Architect's Supplemental Instructions

Architect's ASI No: 023

Project:
Webster University
Interdisciplinary Science
Building

Date Issued: 08/23/2016

S0107

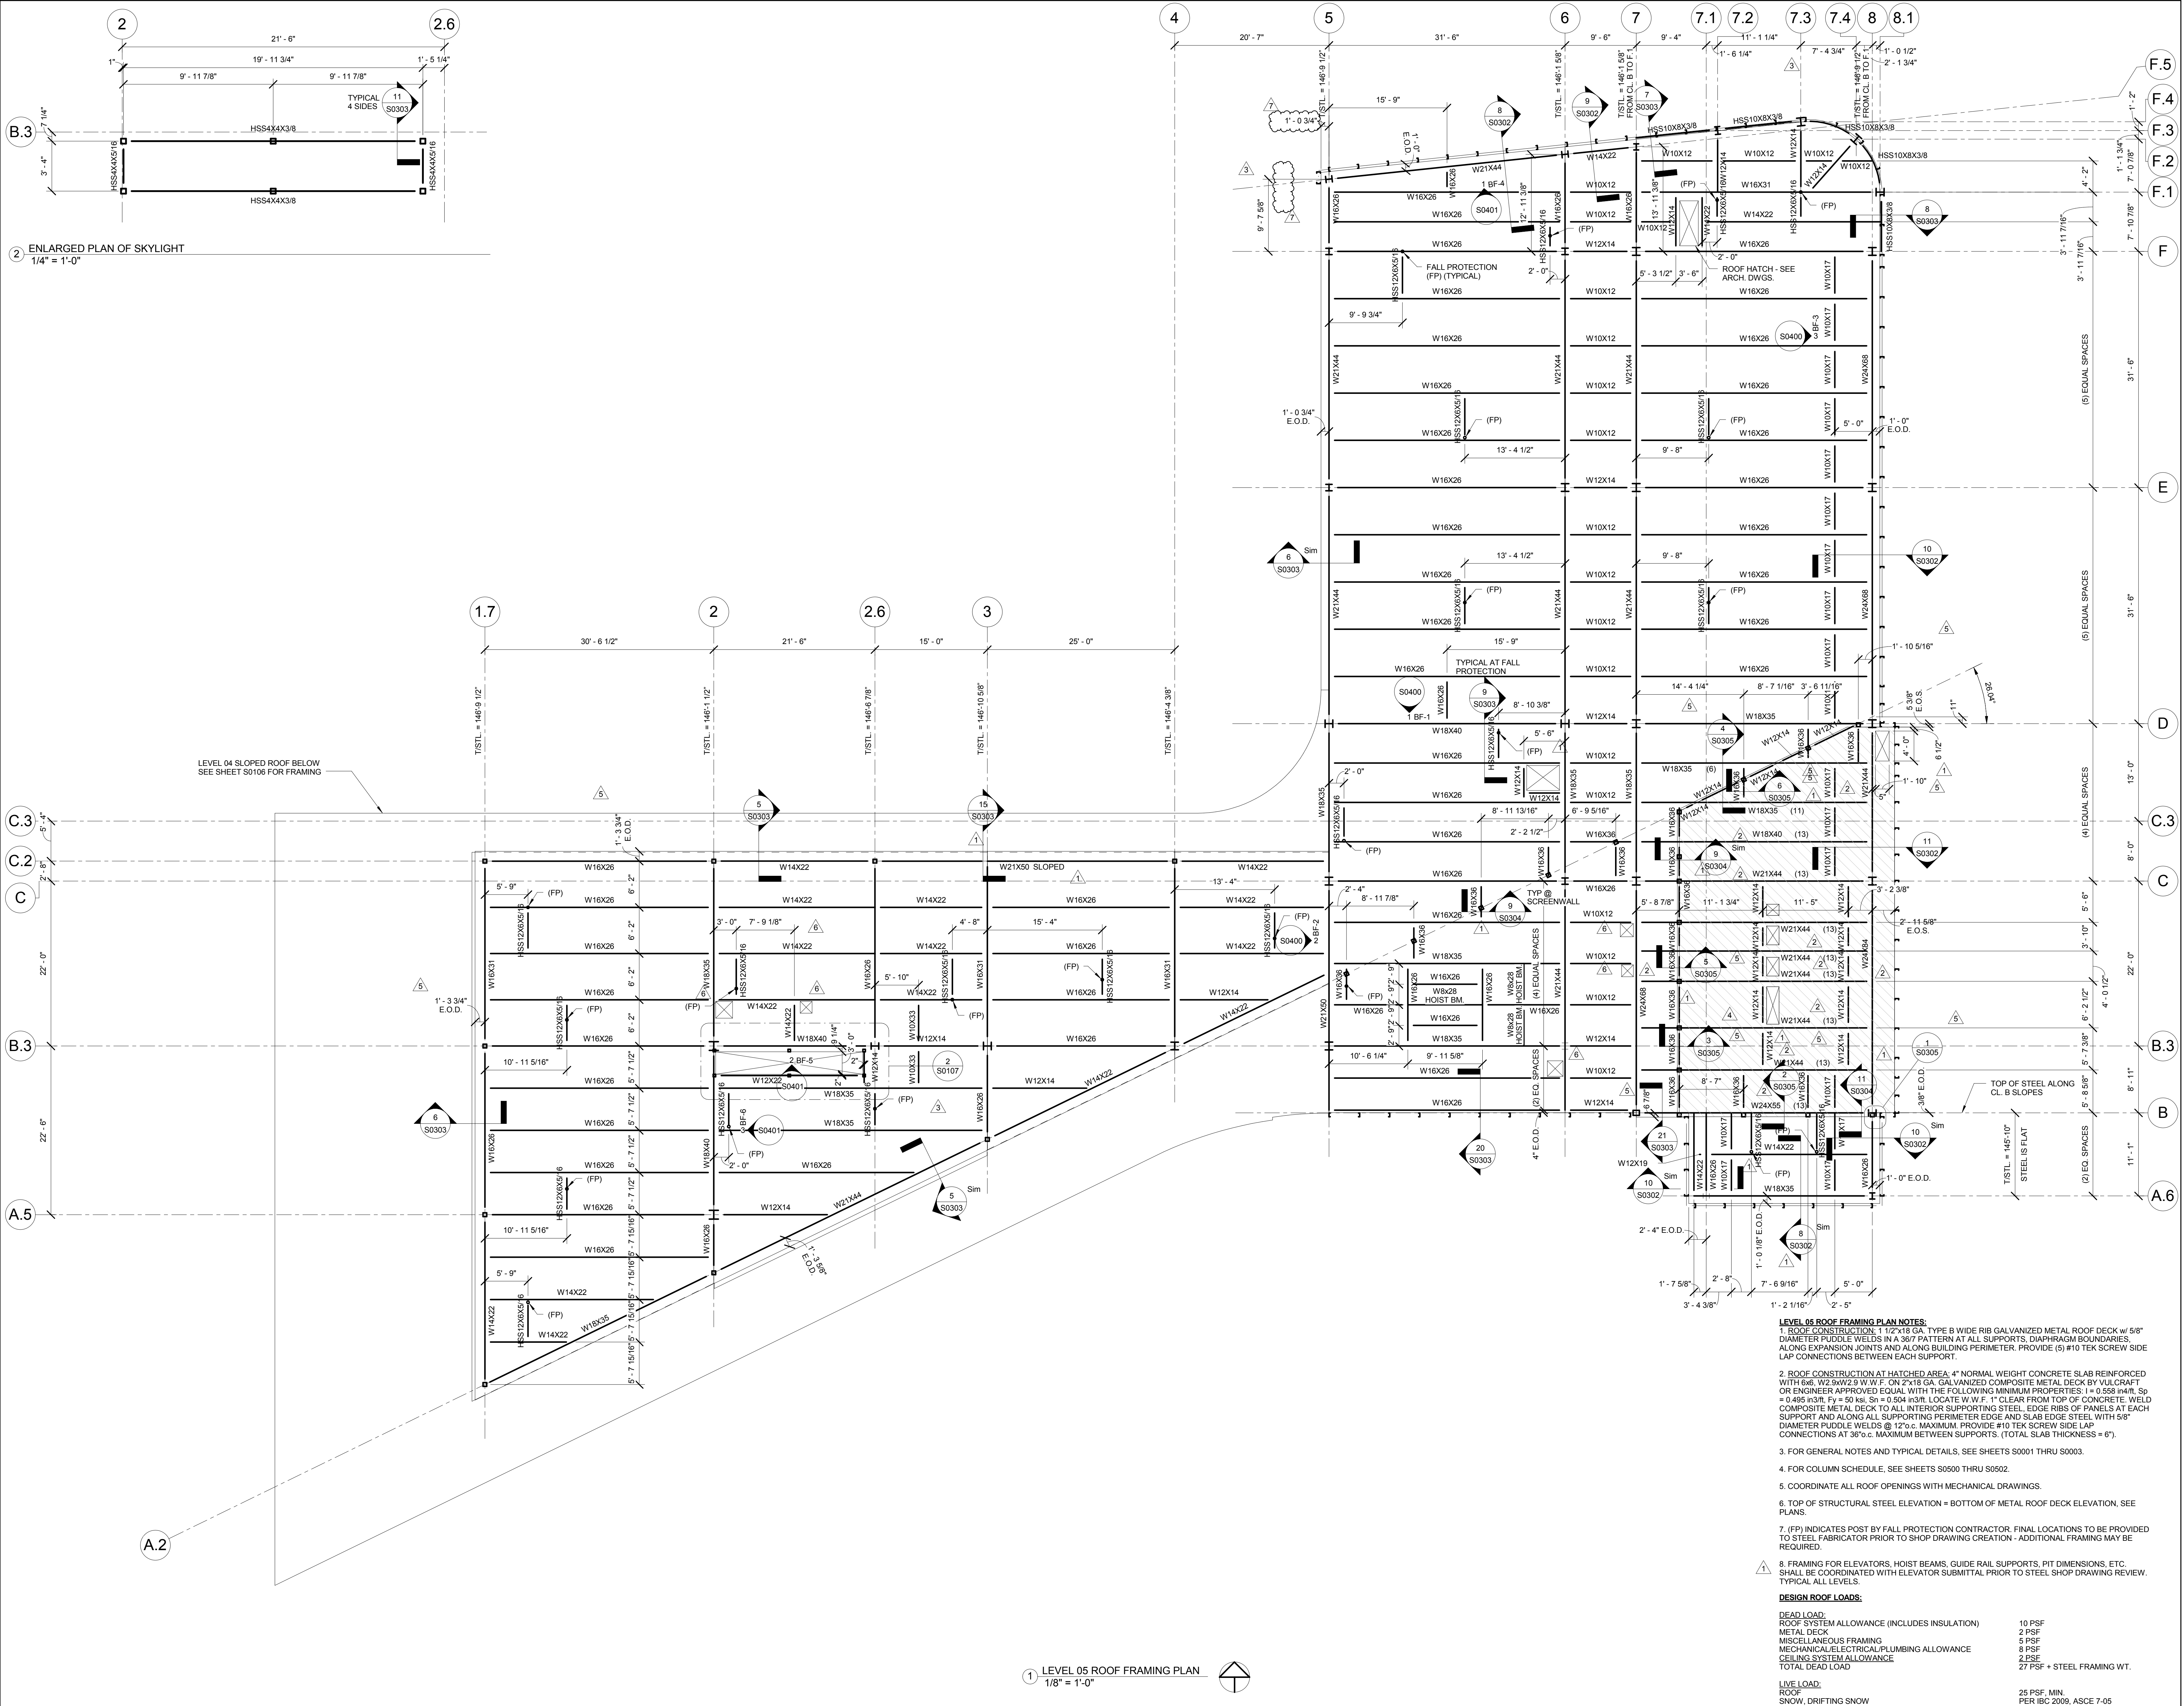
S0107:

Dimensional revisions at Grids F.5-5.
